**Public Safety (PS) Committee Meeting
September 17th, 2026 @ 10:00 am
VIA Conference Call & Town Hall
141 Main St, Townsend, DE 19734**

From: Brian Miller <BMiller@Pennoni.com>
Sent: Wednesday, September 9, 2026 12:51 PM
To: Julie Goodyear
Cc: Earl McCloskey; Dylan Wiggins; Joseph Bangura
Subject: RE: Public Safety Roadway Improvements – Engineering Review
Attachments: Crosswalk & stop sign locations.png

Subject: Public Safety Roadway Improvements – Engineering Review

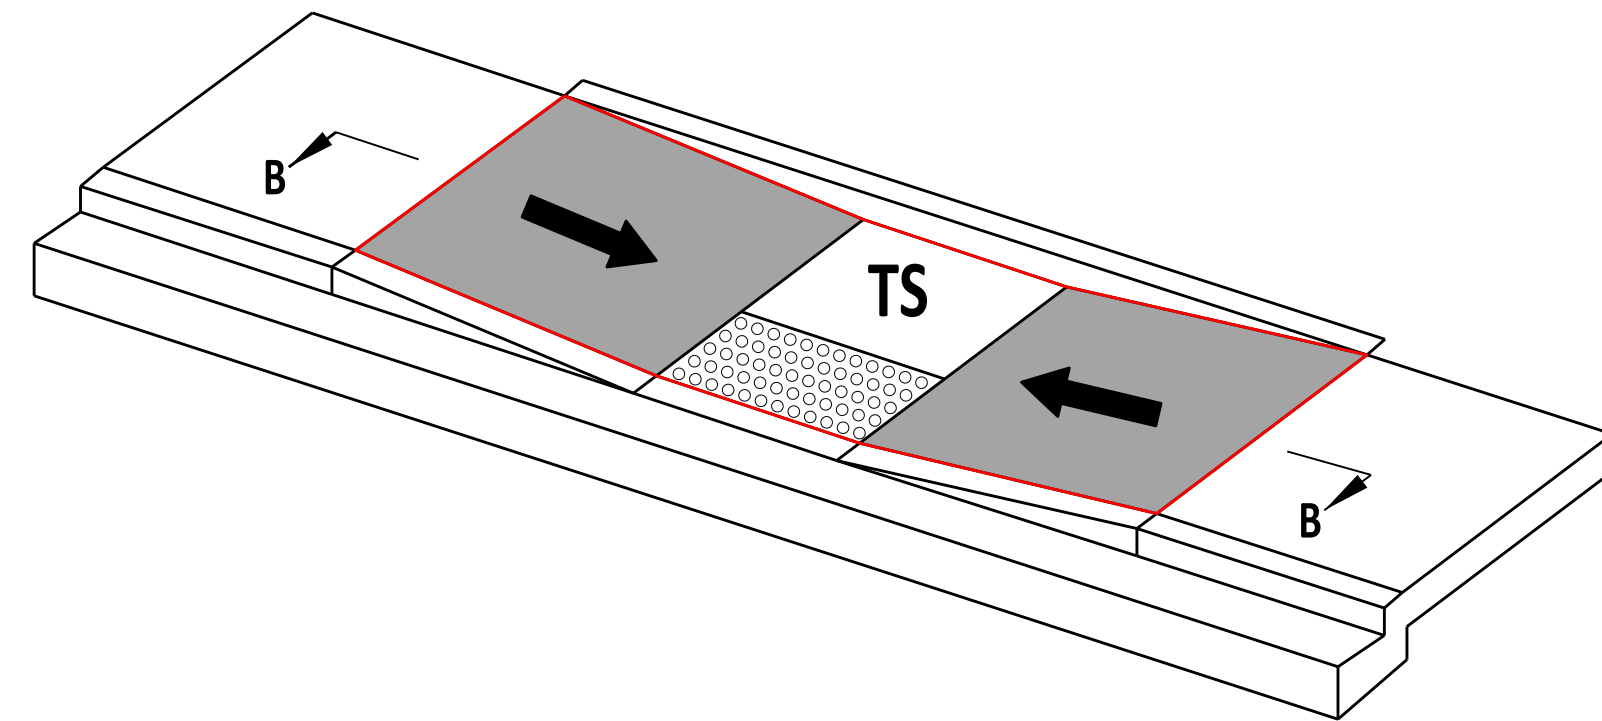
- Upper left of the intersection – ADA ramp should be expanded for full functionality of the crosswalk across Edgar
- General configuration seems appropriate limiting crossings to 2
- Crosswalk should be at least 6' wide piano key (24" stripes); wider to match the ramp width (typically 10' wide on higher speed roads)
- May want to shift stop signs to the stop bar locations at completion of the striping
